### Township of Bensalem, Bucks County, Pennsylvania Notice of Appeal

**RE: 726 River Road – A/L  
File No. 0907.0999.00**

On June 17, 2014, we visited the above property for a stakeout inspection of a proposed porch addition. We failed the stakeout for the following reasons:

726 RIVER ROAD LOT # 22  
BENSLEM, PA 19020  
GINNY SKOCZYLAS  
PORCH ADDITION

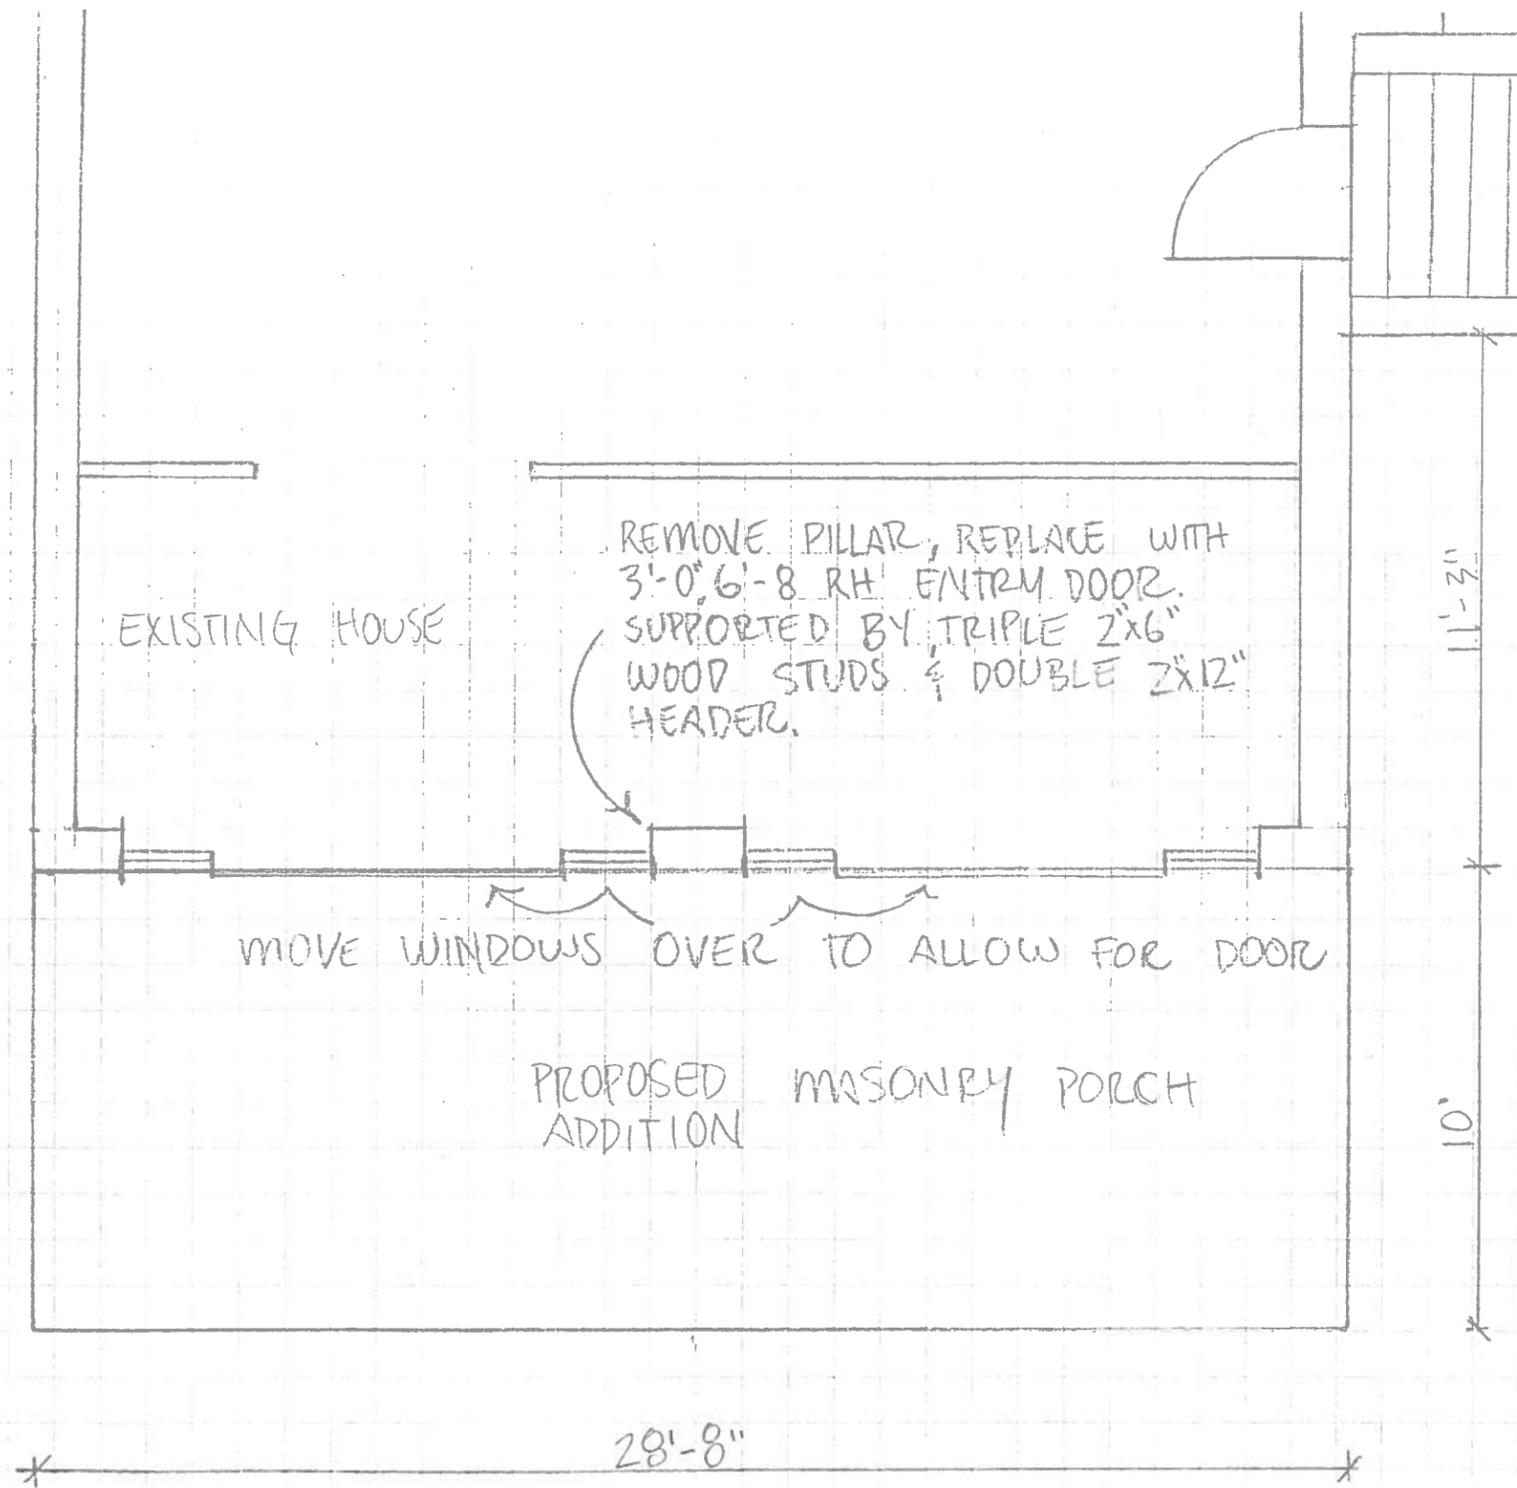
1. The proposed addition appears to be encroaching into the front yard setback area. We measured +/- 7' instead of the 26'3" that was submitted. The minimum setback for your zoning district is 35'. This is in violation of Section 232-153(e)(1)a. A zoning variance is required for this to remain.

1. The distance between the proposed addition must be changed to +/-7' instead of the 26'3".
2. The existing pool must be shown on the plan.
3. Existing garage must be shown on the plan.
4. Existing driveway configuration must be shown on the plan.
5. Any other non-grass areas should be shown on the plan.

At this time, your stakeout inspection has failed. To continue with the proposed construction of the addition, the addition may not encroach into this setback area, or the proper variance must be obtained from the Township.
